113-153 ALDINGTON ROAD (SSD-32722834)

Response to Request for Information – March 2025

Drawing 21-846-C1130

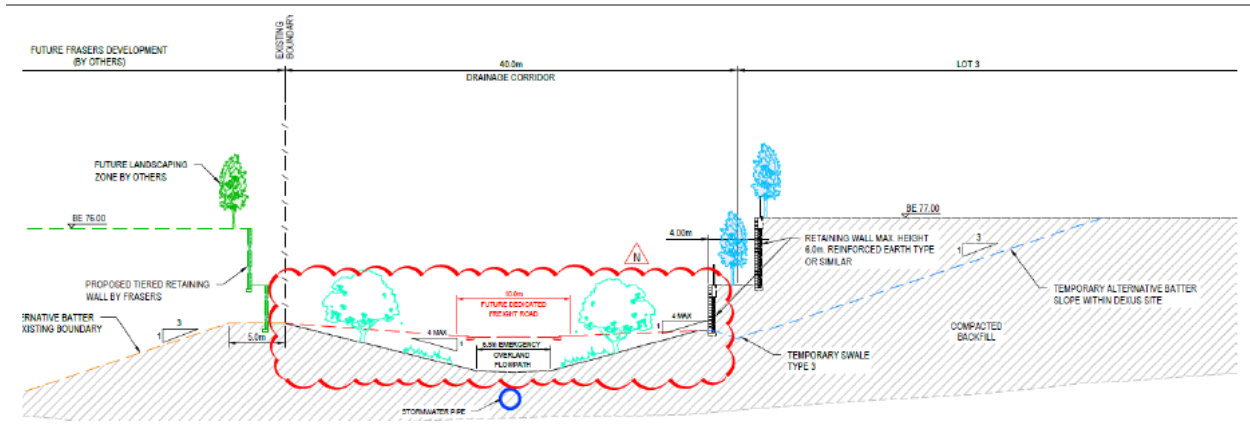
Section 10 on the updated civil drawing 21-846-C1018 indicates there will be fill required in future to accommodate the freight access road (see below). Confirm how this will impact on the landscaping/tree canopy proposed in this area.

The design of the access road will be subject to the ultimate level of the DFR. The cross section is indicative only and is intended to only provide guidance on how the access road maybe constructed in the future.

Referring to 21-846-C1130 provides further explanation of the potential design of the access road and the impacts to the proposed landscape. If and when the access road is constructed, the design and approvals would need to consider the impacts on the existing landscape and as required, the landscape would need to be replaced.

Subject to the future design, the impact to the vegetation could be minimised with lowering the design levels.

As noted on P6 of the Landscape report canopy cover to this area is only relied upon for Stage 1 works. While future design will endeavour to retain vegetation regrading will likely require removal and replacement. A landscape outcome with battered vegetation is considered preferable to retaining walls which may support the drainage and road schemes.
